The ISO received comments on the topics discussed at the November 17, 2020 stakeholder call from the following:

The following are the ISO's responses to the comments.

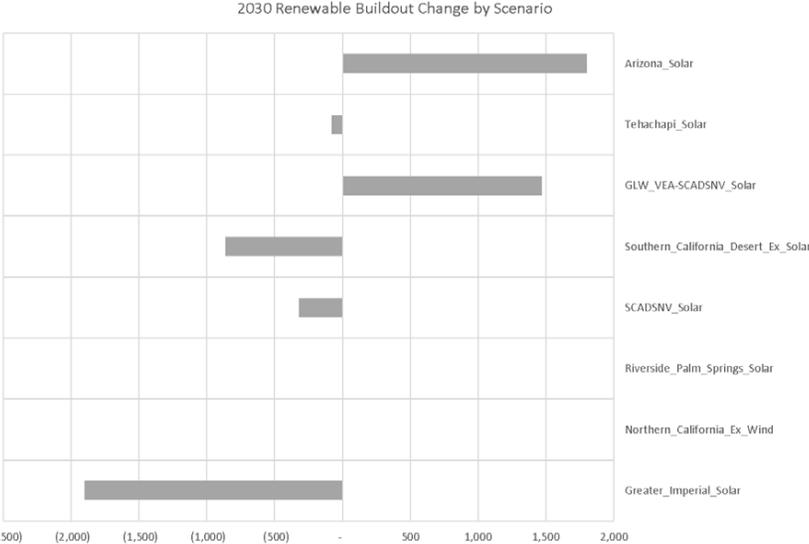
3. GridLiance West Submitted by: Jody Holland		
No	Comment Submitted	CAISO Response
3a	<p>GridLiance Comments on CAISO’s Policy Sensitivity Case 2 Expanded Energy-Only Limit Study</p> <p>GridLiance offers comments in response to the CAISO’s off-peak analysis for Policy Sensitivity Case 2 addressing the expanded Energy Only limits.</p> <p>CAISO’s Off-Peak Analysis Demonstrates Ability to Expand IRP Energy-Only Limits</p> <p>GridLiance appreciates the CAISO’s efforts to publish findings from its study of the Sensitivity Portfolio 2 – the study of expanding the Energy-Only (EO) limits used for the CPUC’s Integrated Resource Planning (IRP) Process. The findings provide helpful input to the CPUC’s process, and release at this time can enable the CPUC to incorporate these findings for their next portfolios. GridLiance strongly encourages the CAISO to pass these results to the CPUC and at this time recommend increases to the transmission limits for those areas studied such that the portfolios are not unnecessarily constrained (using overly low limits) for the subsequent portfolios that will be used for the 2021 – 2022 TPP.</p> <p>The CAISO’s results show that the renewable buildout of Sensitivity Portfolio 2 (SENS-2 in the CAISO November 17, 2020 slides) could be managed in almost all cases by renewable action schemes (curtailing the renewable generation if need be), dispatching storage, or siting portfolio storage in the areas. The three areas that seemed to warrant transmission upgrades are Tehachapi, the VEA/GLW area of Southern Nevada, and Westlands. The CAISO summarized these results on slide 100 of their November 17 results reflecting the off-peak (i.e., periods of high renewable curtailment) results.</p>	<p>The comment has been noted.</p> <p>The CAISO notes, as is indicated in footnote 114 (page 212) of the draft transmission plan, that the CAISO’s Cluster 13, Phase 1 generation interconnection studies have identified concerns with the planned RAS in the Eldorado and VEA areas that need further analysis. The identification and future resolution of these concerns will need to be incorporated in future studies of the Eldorado and VEA area system constraints, and the results of those studies could be considerably different.</p>

No	Comment Submitted	CAISO Response																															
	<p style="color: #4F81BD; margin: 0;">Summary of off-peak deliverability assessment results</p> <ul style="list-style-type: none"> Pre-contingency renewable curtailment was identified to varying extent in the base and sensitivity portfolios In addition to RAS, transmission upgrades, dispatching storage behind the constraint in charging mode and adding storage (subject to on-peak deliverability) are considered to mitigate renewable curtailment

No	Comment Submitted	CAISO Response																																																																																																																																		
	<div style="border: 1px solid #ccc; padding: 10px;"> <h3 style="margin: 0;">Mitigation Options</h3>

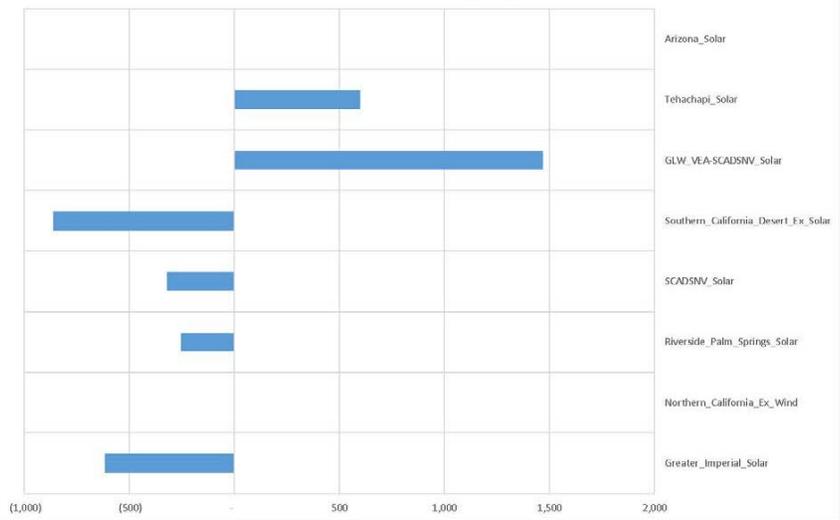
<ul style="list-style-type: none"> RAS is expected to address pre-contingency curtailment in other areas <p style="font-size: small; margin-top: 10px;"> California ISO Page 100 </p>	Renewable Transmission Zone	Constraint	Battery Storage Behind Constraint (Base/Sens-1/Sens-2) (MW)	Renewable Curtailment (Base/Sens-1/Sens-2) (MW)	Potential Mitigation			Transmission	Dispatch Storage (Base/Sens-1/Sens-2) (MW)	Add Storage (Base/Sens-1/Sens-2) (MW)	Tehachapi (Whirlwind)	Whirlwind 500/230 Banks	0/267/305	0/120/240	Whirlwind 500/230kV No. 4 (~\$100M) - Sens-1, Sens-2	0/120/240	N/A	Southern NV (CAISO)	VEA/GLW Area Constraints	0/40/40	0/0/830	Multiple options (~\$90M-\$192M each) - Sens-2	0/0/NA	0/0/790	Westlands	Kettleman- Gates 70 kV constraint	0	10/10/10	Reconductor Kettleman-Gates 70 kV line - Base, Sens-1, Sens-2	N/A	10/10/10	
Renewable Transmission Zone	Constraint					Battery Storage Behind Constraint (Base/Sens-1/Sens-2) (MW)	Renewable Curtailment (Base/Sens-1/Sens-2) (MW)	Potential Mitigation																									
		Transmission	Dispatch Storage (Base/Sens-1/Sens-2) (MW)	Add Storage (Base/Sens-1/Sens-2) (MW)																													
Tehachapi (Whirlwind)	Whirlwind 500/230 Banks	0/267/305	0/120/240	Whirlwind 500/230kV No. 4 (~\$100M) - Sens-1, Sens-2	0/120/240	N/A																											
Southern NV (CAISO)	VEA/GLW Area Constraints	0/40/40	0/0/830	Multiple options (~\$90M-\$192M each) - Sens-2	0/0/NA	0/0/790																											
Westlands	Kettleman- Gates 70 kV constraint	0	10/10/10	Reconductor Kettleman-Gates 70 kV line - Base, Sens-1, Sens-2	N/A	10/10/10																											
	<p>Of these three areas, the upgrades to the VEA/GLW system can provide substantial reductions in curtailment for relatively low-cost transmission enhancements. The CAISO's presentation further displayed options it considered for the VEA/GLW area in its slide 48.</p>
